August 25, 2009
NRC3-09-0021

References: 1) Fermi 3
Docket No. 52-033
2) Letter from Jerry Hale (USNRC) to Peter W. Smith (Detroit Edison),
“Request for Additional Information Letter No. 7 Related to the SRP Sections
03.07.01-1, 12.03-12.04-3, 05.03.01-1, 03.07.01-2, 03.07.02-1, 12.02-3, and
12.02-4 for the Fermi 3 Combined License Application,” dated June 23, 2009

Subject: Detroit Edison Company Response to NRC Request for Additional Information
Letter No. 7

Figure 1 – TLD Locations on Fermi Site
(following 1 page)

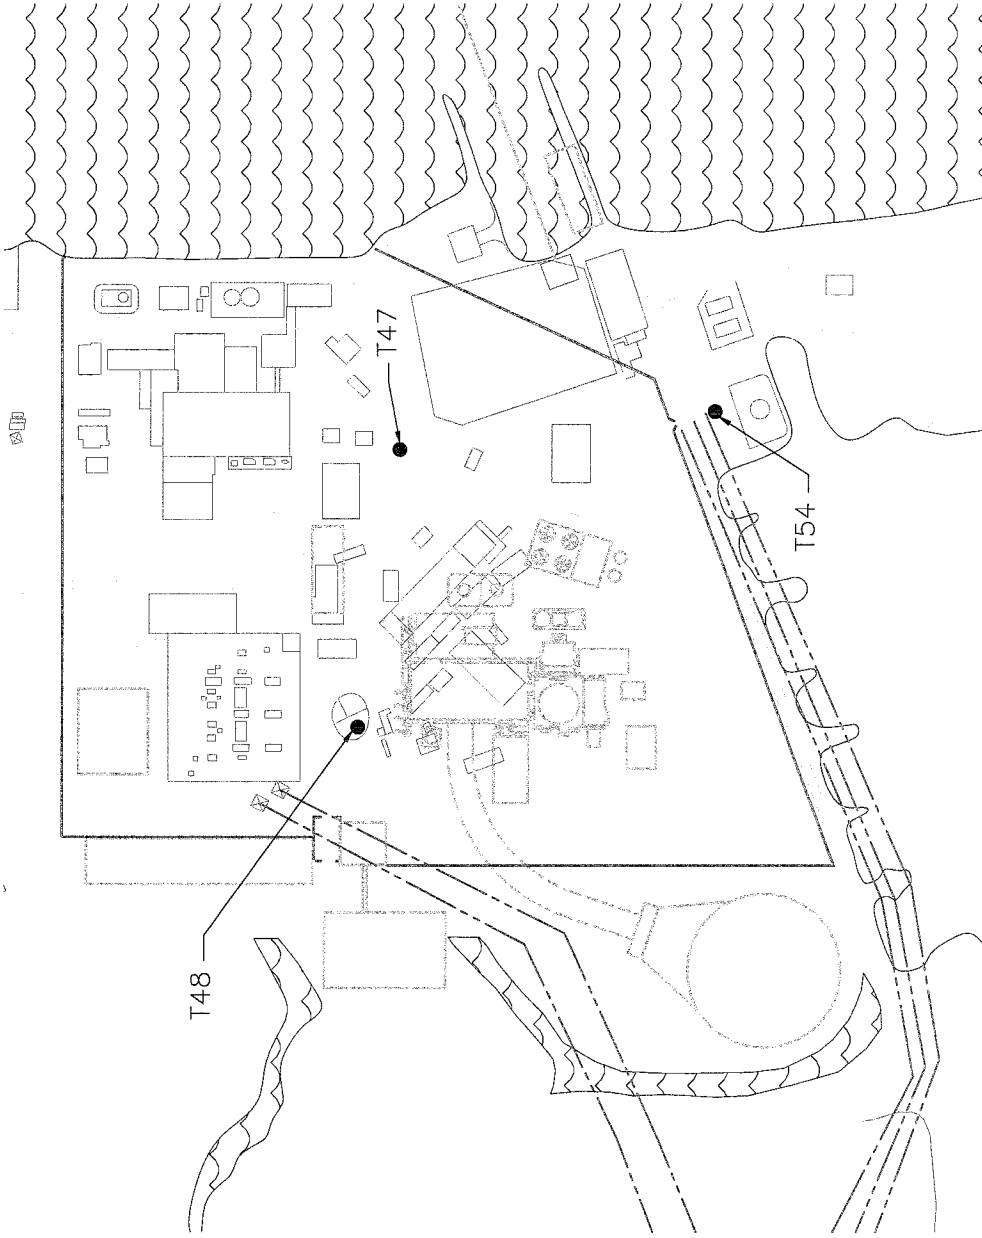
Section 12.4 of the EF3 COLA refers to the EF3 Environmental report for dose to Construction Workers. Upon reviewing the Construction Worker Dose, as reported in Section 4.5 of the EF3 Environmental report, it was noted that additional information should be included in Section 12.4 of the COL:

- *specific construction activities and the number of workers used in construction worker dose calculations.*
- *effects of future decommissioning activities of Fermi 1 on Fermi 3 construction worker dose.*
- *plans for radiological monitoring of the Fermi 3 construction site to verify construction worker dose calculations.*

Examining the Fermi 3 site plan arrangement, ER Figure 4.5-1, and the location of the monitoring TLDs for Fermi 2, ER Figure 4.5-2, shows that there are three TLDs locations that could be used to obtain exposure rates for use in whole body dose calculations for Fermi 3. TLDs T47, T48, T54, Fermi 2 and Fermi 3 are shown together on Figure 1 of this response (see Figure 1 of attached Enclosure 1). TLDs T47, T48, and T54 are outside the Fermi 2 secure operating area, monitor areas accessible during construction activities at the power block portion of the site, and would conservatively represent exposure rates for construction activities at the south end of the site.

Of the three, TLD 48 was selected to represent dose levels for construction activities. TLD T54 is the farthest location from Fermi 2 and as such it would not be conservative to use the TLD T54 exposure rate as representative for whole body dose calculations for the power block construction site. Although the dose rate for TLD T47 is the highest of the group, its location is just outside of the Fermi 2 protected area and well removed from the eventual location of the Fermi 3 structures. Further it is not reasonable to assume that power block construction workers would spend significant periods of time in this area as it is well removed from the Fermi 3 power block construction area.

TLD T48 is closest to the Fermi 3 power block construction area, and is also located at one of the shortest distances between Fermi 2 and the Fermi 3 power block construction site. Therefore, TLD T48 provides a reasonable location to develop a representative dose for the Fermi 3 site construction workers.
